DONALD C. COOK NUCLEAR PLANT UNIT NO. 1

Amendment No. 33
License No. DPR-58

DONALD C. COOK NUCLEAR PLANT UNIT NO. 2

Amendment No. 14
License No. DPR-74

FIGURE 6.2-1 Offsite Organization for Facility Management and Technical Support

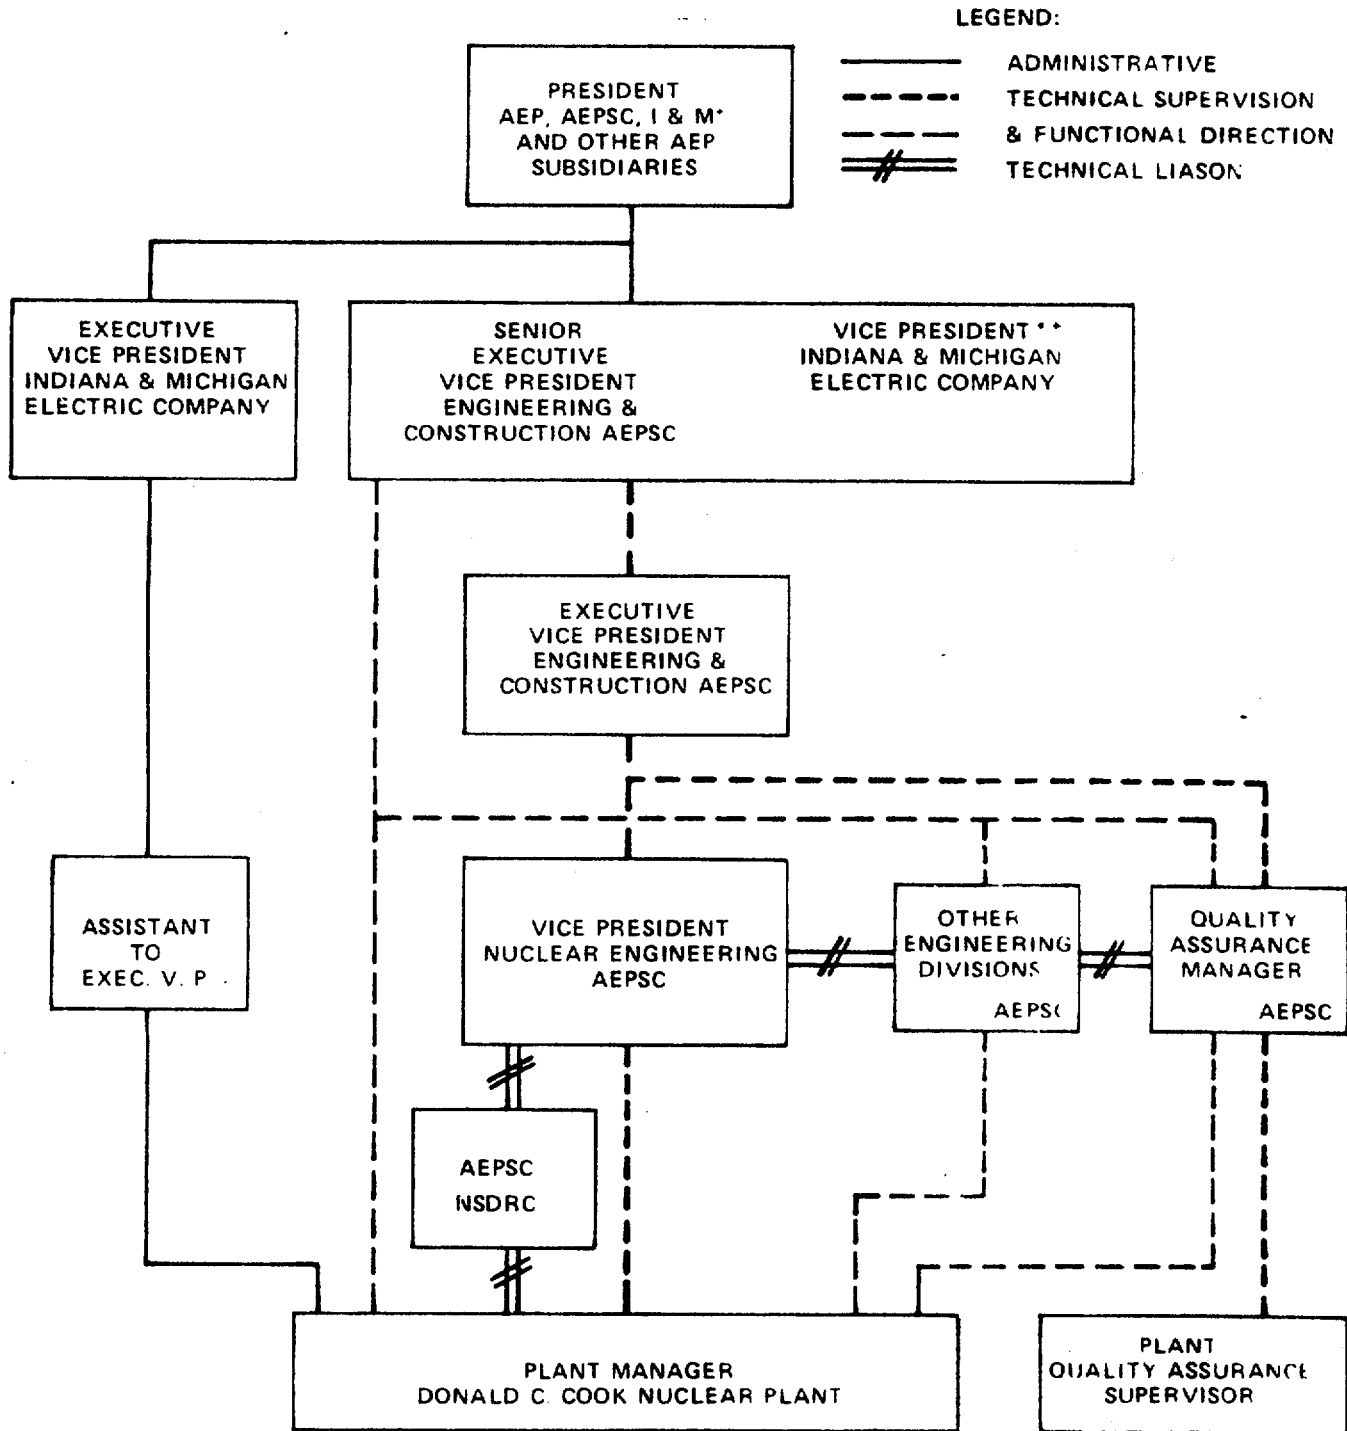
In addition to the merger, the licensees brought to our attention certain title changes within their organizations. We have taken this opportunity to correct the Administrative Controls area of the Technical Specifications. These changes in titles will have no effect on the continued safe operation of the D. C. Cook Nuclear Plant.
